Introduction

Detailed comments on scheme as proposed in consultation.

1A Sheet 1 Lindsay Road

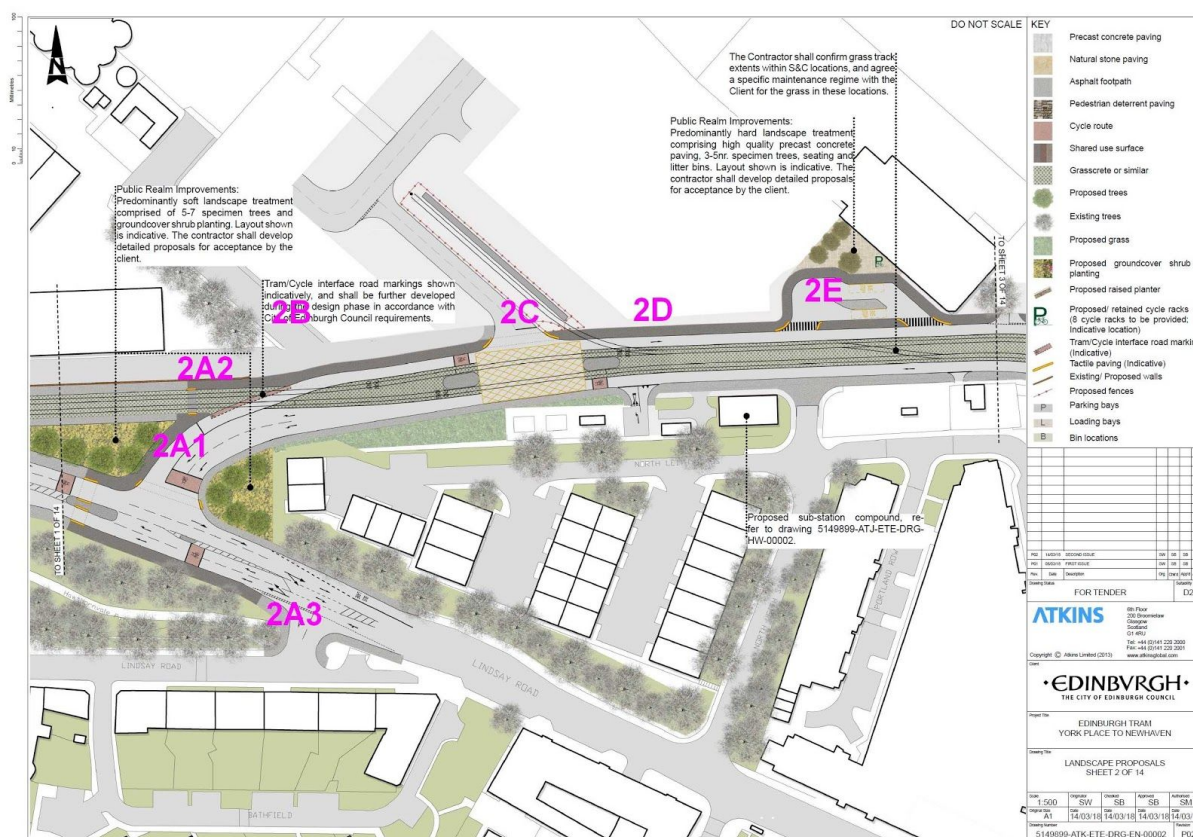
Presuming that right turns into Sandpiper Drive are permitted (there is no right turn marking shown), an advanced stop line and early cyclist release should be added to the junction to assist cyclists turning right into Sandpiper Drive. There is currently a delayed right turn phase at this junction.

If the right turn is to be banned, then alternative cyclist facilities should be provided.

There is likely to be growing demand for cycle facilities from the new developments in Western Harbour. Appropriate facilities should be provided for them to access the cycle network to the South (linking up with the North Edinburgh Path Network) and to homes and businesses in the surrounding areas.

Cycle facilities to the East and West should also be considered with space being taken if necessary from the 3 traffic lanes that are being retained on Lindsay Road.

It's good to see that cycle parking is to be provided at the tram stop, however, cyclists will need to be able to get to the parking via suitable facilities and will also be arriving with their bikes on the tram. Cycle parking should provide for a significant number of cyclists at this key terminus with suitable shelter and security features.

2A Sheet 2 Melrose Drive - Junction with Lindsay Road and Hawthornvale Path

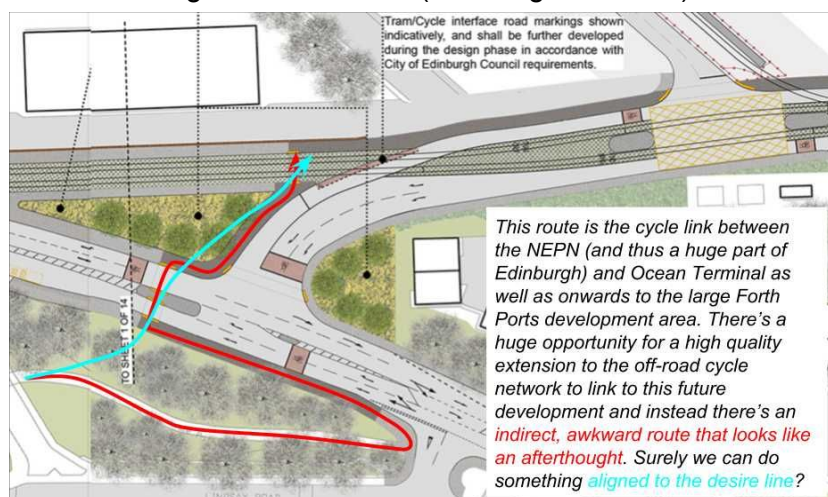
Spokes is concerned that this new road will encourage increased traffic into the area. Is its introduction required for some essential reason?

This will area will become a key cycling thoroughfare between the North Edinburgh Path Network (NEPN) and future Forth Port developments (as well as access to other areas to the East). A cycle-friendly connection is therefore of critical importance.

Spokes preferred arrangement would be for a tunnel under Lindsay Road, connecting the cycleways on the North and South sides of the road and giving easy access to and from the North Edinburgh Path Network. (See diagram below)

Alternatively, a ramp that goes straight up to Lindsay Road would be preferable to the proposed awkward, indirect routing along the footways.

2A1 The proposed connection incorporate paths, waiting areas and crossings are not sufficiently wide enough, including along the South side of Lindsay Road.

2A2 The proposed tram crossing should be unsignalised unless there are safety concerns.

2A3 The turn onto the Hawthornvale cycleway needs to be widened to a convenient angle for cyclists.

2B Sheet 2 Melrose Drive link to Sandpiper Drive

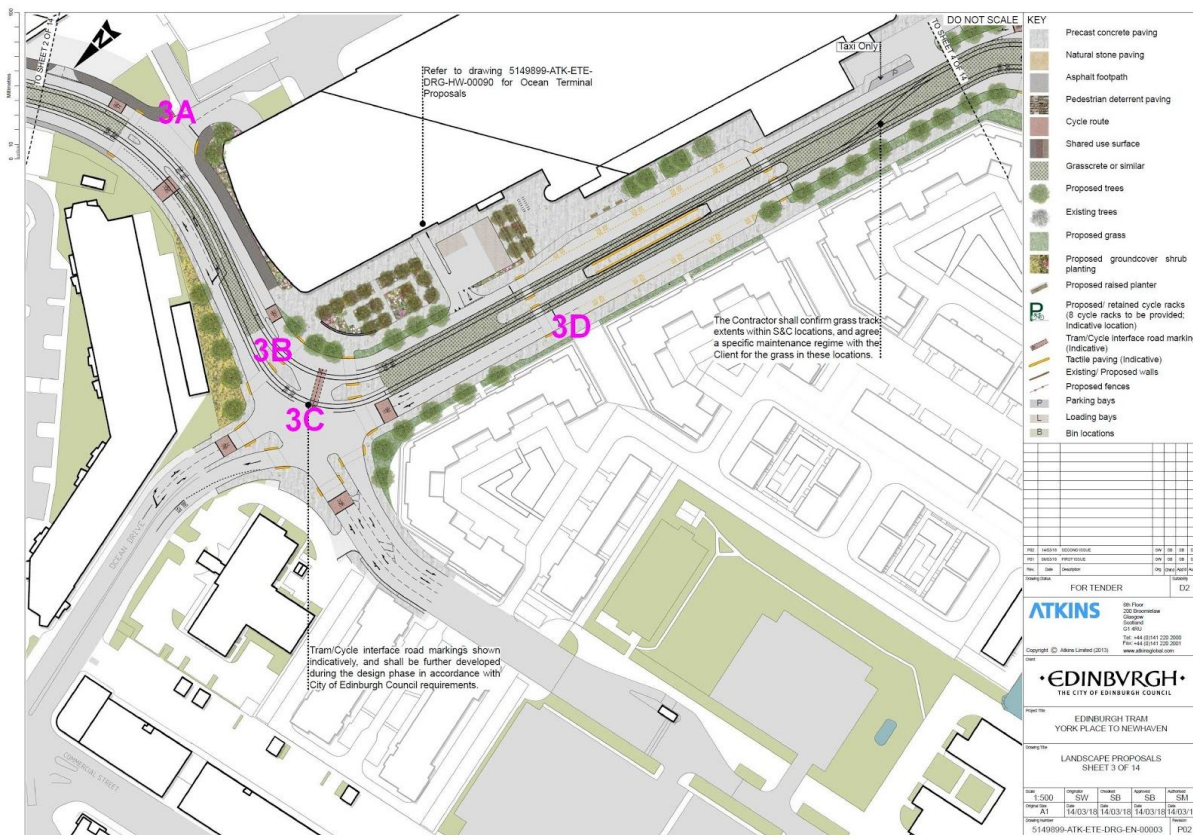
A cycle link needs to be provided to the continuation of Melrose Drive for cyclists heading to Asda and Western Harbour via Sandpiper Drive.

Cyclists need to be able to be able to cross the tram tracks at a safe angle and with signalised controls as appropriate.

2D Shared use not appropriate - should be segregated as stated in the area-wide comments (See Area Wide Comments A1).

The bus/coach stopping area needs to be re-designed to allow direct, safe transit by cycles. The stop is presumed to be infrequently used and therefore pedestrians and cyclists should have priority across the access points. If a floating bus-stop arrangement is required, then the cyclepath should have a more straightforward route than indicated and be clearly demarcated from the pedestrian areas. It should be made clear to road and cycle/footway users who has priority and the direction of approach of vehicles (eg if vehicles are turning right into the stop).

3A Melrose Drive junction with access road to rear (West) of Ocean Terminal

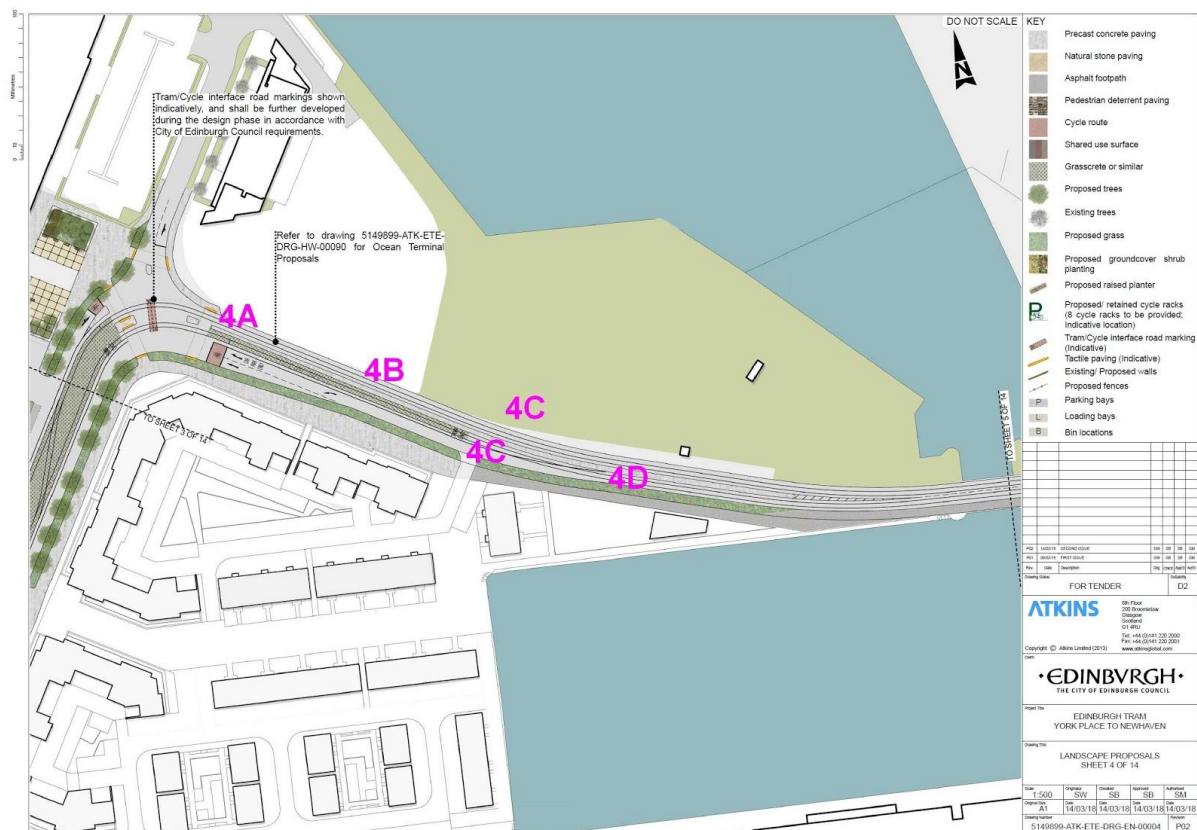
A safe crossing for cyclists needs to be provided with signals as appropriate.

3B This crossing should be a Toucan with access for cyclists from Commercial Street.

The new crossroad junction should provide safe angles for cyclists to cross, with early release at the signals. Links need to be provided to cycleways coming from Melrose and Ocean Drives.

A new segregated bi-directional cycleway should be provided on the East side of the road, across from Ocean Terminal, whilst retaining access to the cycle parking.

4 Ocean Drive (North) to Rennie's Isle

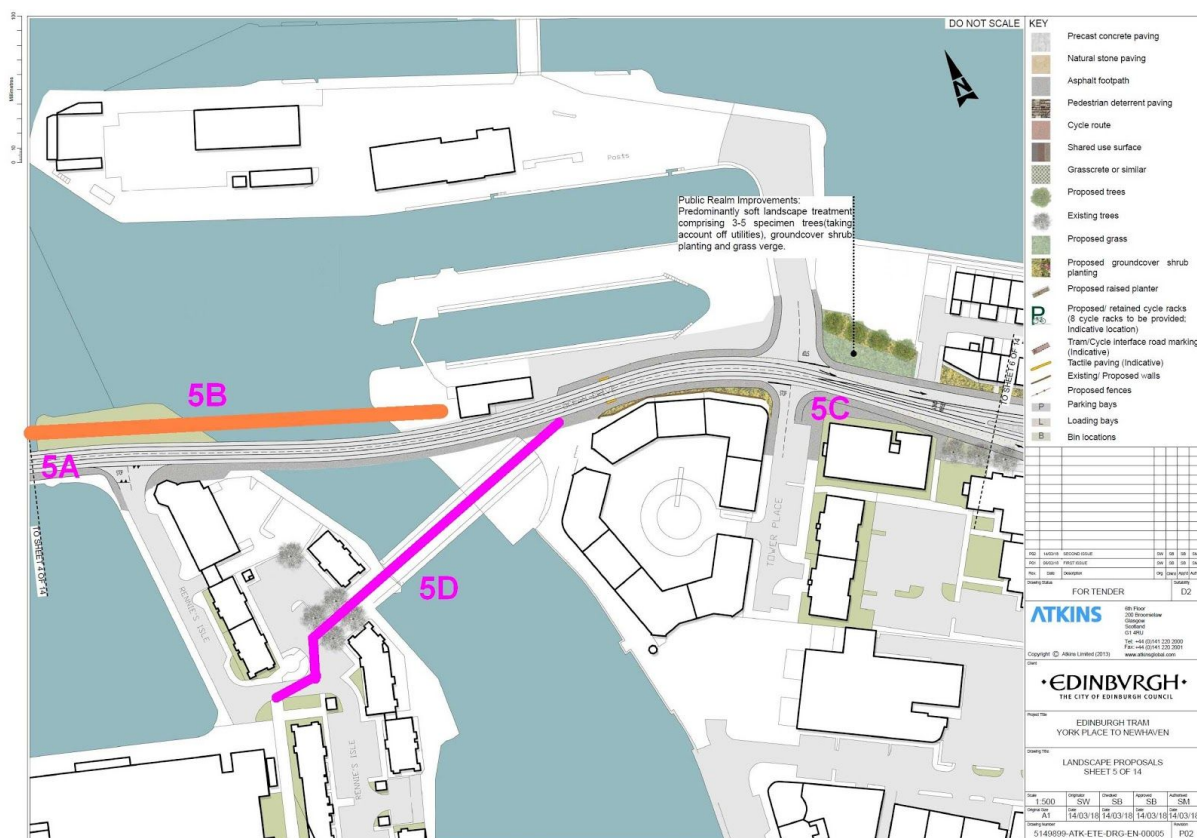
As stated in Area Wide Comments A1, segregated cycling provision needs to be included in this section. This is critical to providing a coherent cycle link between the NEPN and the Forth Ports development area.

Why is a median strip required here? It will form a barrier to free movement of pedestrians and cyclists and potentially takes up space that could be used for cycling facilities.

This section appears only sufficiently wide for the tramway, with little room between the rails and the kerb for people to cycle safely on the road. The traffic lanes should be widened to make sufficient room for cyclists - at least 1.5m.

Cycling access needs to be provided to/from the new developments to the North and South. These developments should bring a lot more active travellers to the area and developers should provide suitable facilities within their developments.

A shared use cycleway is not appropriate at this location, given the expected number of active travellers that will be moving into and passing through the area. A 2-way cycleway on one side of the tramway may be sufficient if sufficient crossing points are provided.

5 Ocean Drive (North) - Rennie's Isle to East of Tower Place

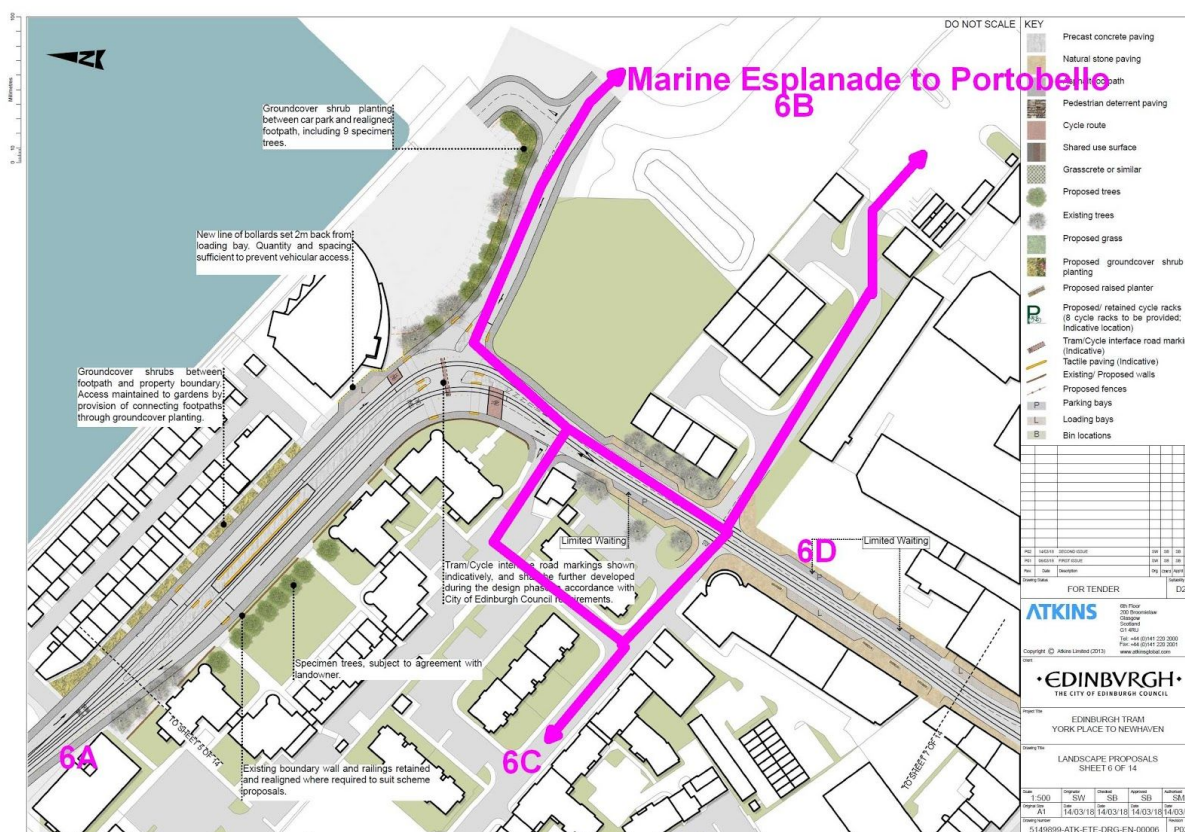
5A The tramway continues to take up much of the carriageway (as in 4) with little space for cyclists. As in 4, the carriageway should be widened or segregated/shared paths provided for cyclists.

5B Tower Place Bridge is particularly narrow and the addition of an iconic cycling bridge would make for a good solution for joining up segregated cycleways along the North side of Ocean Drive

5C The proposed junction at Tower Place, narrows considerably for Westbound users. Cyclists wishing to turn into Tower Place, should be given the option of joining the wide footway on the corner to make the left turn and continue through to The Shore.

5D Alternative/Additional Proposal - consideration should be given to providing a pedestrian and cycling crossing over the Victoria Swing Bridge to Rennie's Isle, providing a cycle and pedestrian link through Rennie's Isle to Victoria Quay, for access to the Scottish Government Offices and via the lane (that would require some resurfacing to form a suitable cycleway) along the back of Commercial Street and via a new crossing through to Ocean Terminal. (Victoria Quay is closed to through traffic, being the car parking for the Scottish Government Offices.) This would also form a useful link for cyclists south to "The Shore" as a destination, plus connections through to Warriston - Leith cycle path needs creating/improvement.

6 Ocean Drive to Constitution Street North

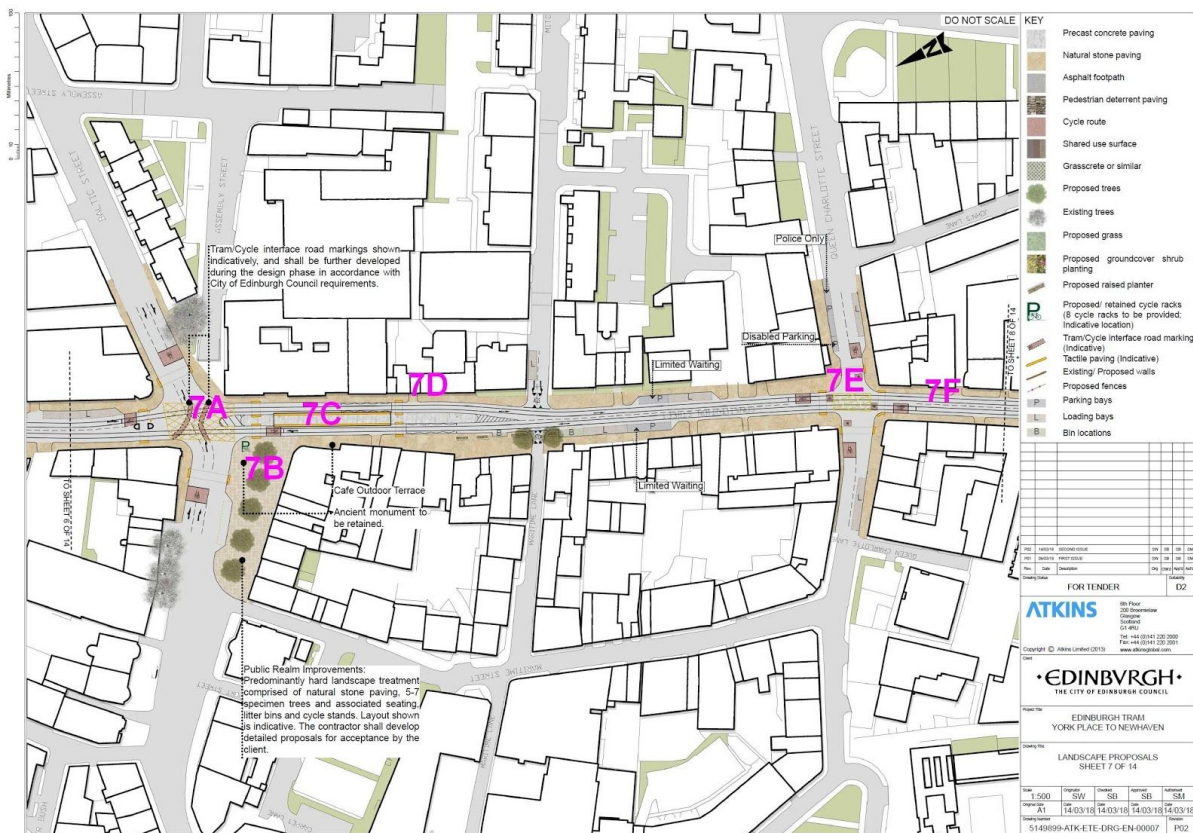
6A Westbound on Ocean Drive, two lanes (one with tramlines, one without) merge into one lane with tramlines. Will there be room for safe cycling (1.5m between kerb and rails)?

6B/6C Safe cycle provision needs to be provided for cyclists to head out of the "Inset A" road from the new development to the North East. The entire area to the East should eventually be redeveloped and provide a promenade cycleway link to Marine Esplanade and on to Portobello (6B). There should at least be room for cyclists to get to Tower Street Lane/Constitution Place and through to Tower Street to the West (6C) but ideally we would want to be able to get to Tower Street should it become a through route past the new developments north of Salamander Street.

6D Segregated cycling facilities needed along Ocean Way/ Constitution Street. Parallel alternatives should also be considered.

7 Constitution Street to Queen Charlotte Street

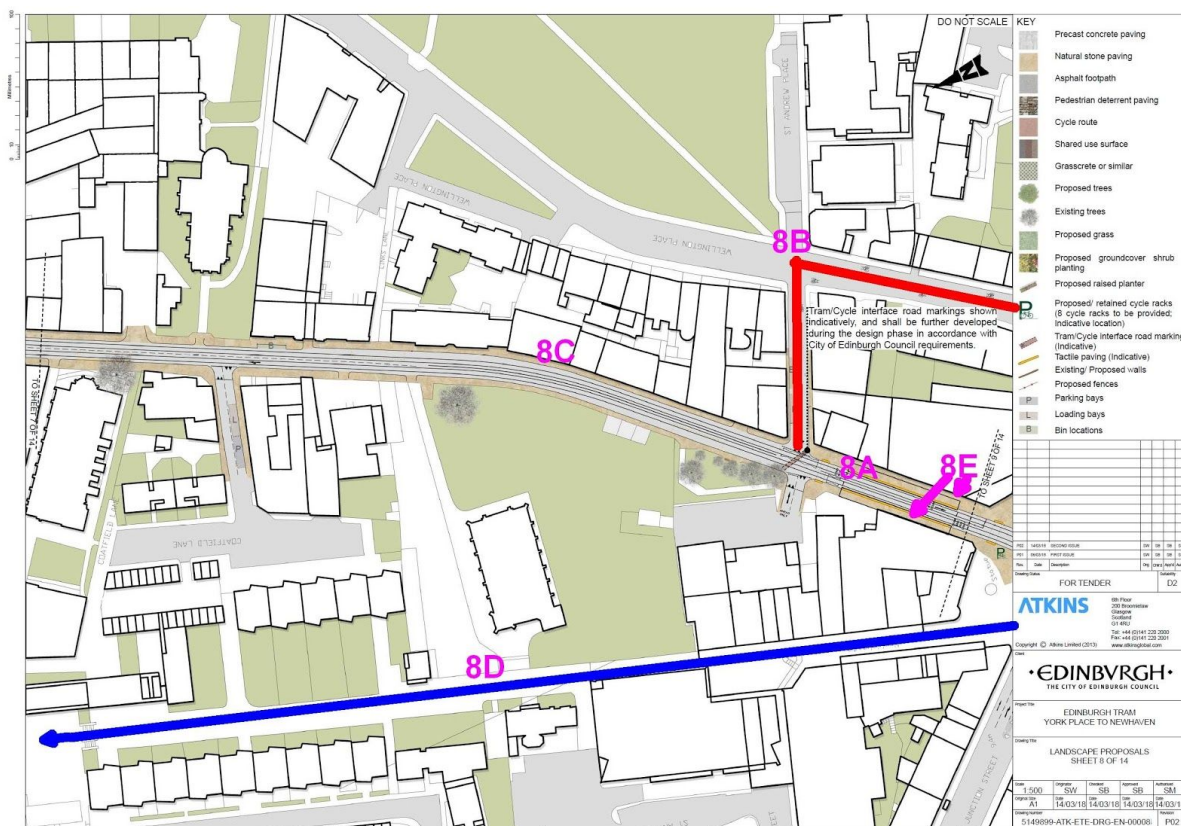
7A 2-stage right turns should be provided at Bernard St junction.

7B The extended public realm at Bernard St should allow for cycle access from Constitution Street through to Bernard Street.

7C Tram stop at junction would appear to block motor traffic heading from the Bernard Street/Baltic Street junction south into Constitution Street. Will the traffic lights have filters that will stop left or right turns when a tram is in the stop?

7D Segregated cycle facilities need to be provided and parallel alternatives considered. Space should be available as the existing roadway mostly supports at least 2 lanes of traffic in addition to parked vehicle.

7E The junction arrangement at Queen Charlotte Street needs redesigning to allow for safe cycling. The ASZs and the 2-stage bike boxes are dangerously situated in the middle of the tram tracks and the tracks appear to be only 1m from the kerb which is insufficient space for cyclists to ride safely.

7F There appears to be no median strip on Constitution Street. How will the tram wires be suspended and can the same approach be taken on Leith Walk?

8 Sheet 8 Constitution Street to Laurie Street

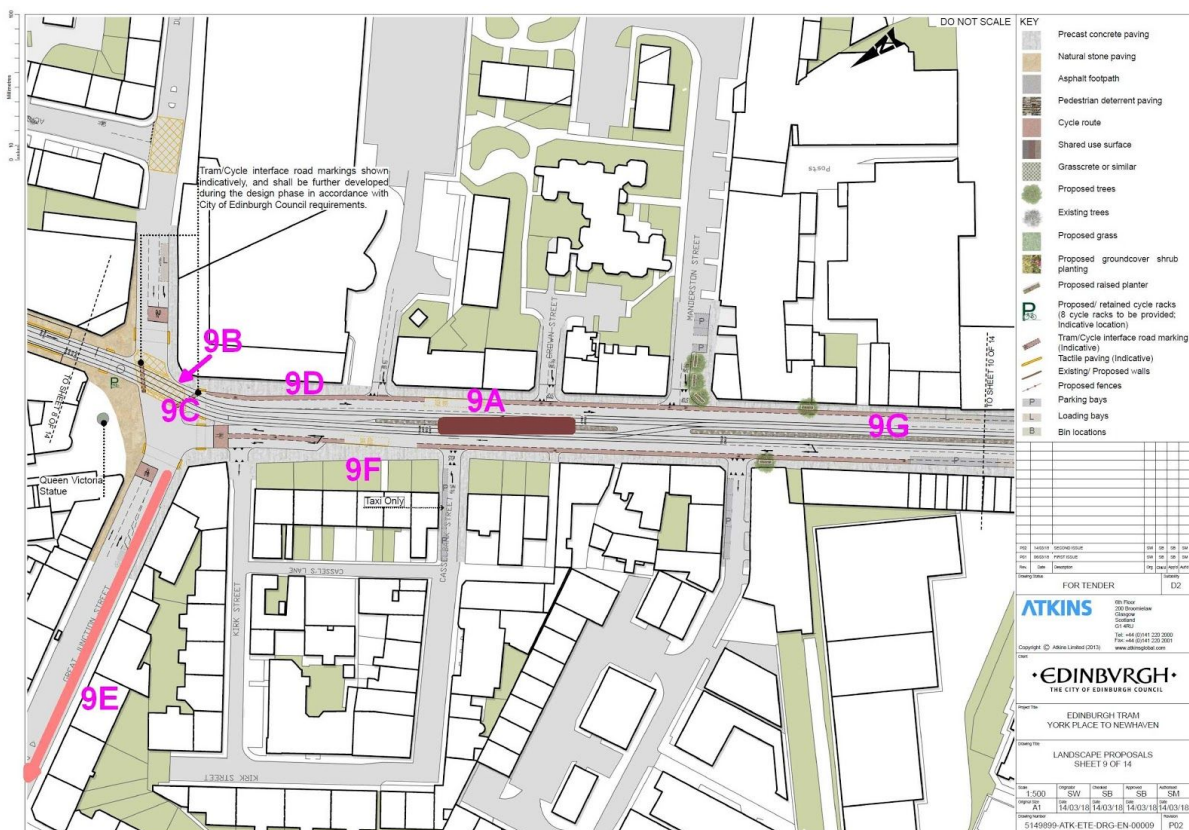
8A Spokes proposes that the tram-stop is moved to the foot of Leith Walk. This is a large open area that would provide free access for pedestrians and create a more appealing “place” than could be achieved in the constricted area at the start of Constitution Street. It would also make for a better tram/bus interchange and easier crossing for pedestrians. The space relinquished would allow space for segregated cycling on Constitution Street (where there is currently room for parked vehicles and 2 lanes of traffic) and avoid the need for the proposed alternative route via Academy and Laurie Street (8B in red).

8B The alternative cycle route via Laurie Street and Academy Street is not suitable for all ages and abilities of cyclists. It is a detour, it adds more turnings, the surface is cobbled and there is a lot of parking in what would be the cycleway. Southbound cyclists would have an unsignalised crossing of busy Duke Street whilst Northbound ones will have to make the awkward crossing at Duke Street (see Sheet 9) and make 2 unnecessary crossing of the tram tracks..

8C Segregated cycling provision should be included along the length of Constitution Street.

8D Cycle access through NewKirkgate, a historic main through-route from the Foot of the Walk, should be carefully investigated, although we appreciate there are some difficulties to overcome.

8E Another though not highly recommended option would be to allow cycling behind the tram stop walkway, should it remain on Constitution Street. There appears to be sufficient space but examination of more detailed designs would be required.

8F Further cycle links to eg to The Shore and Ocean Terminal should also be explored, for example via Great Junction Street and Henderson Street (see 9E)
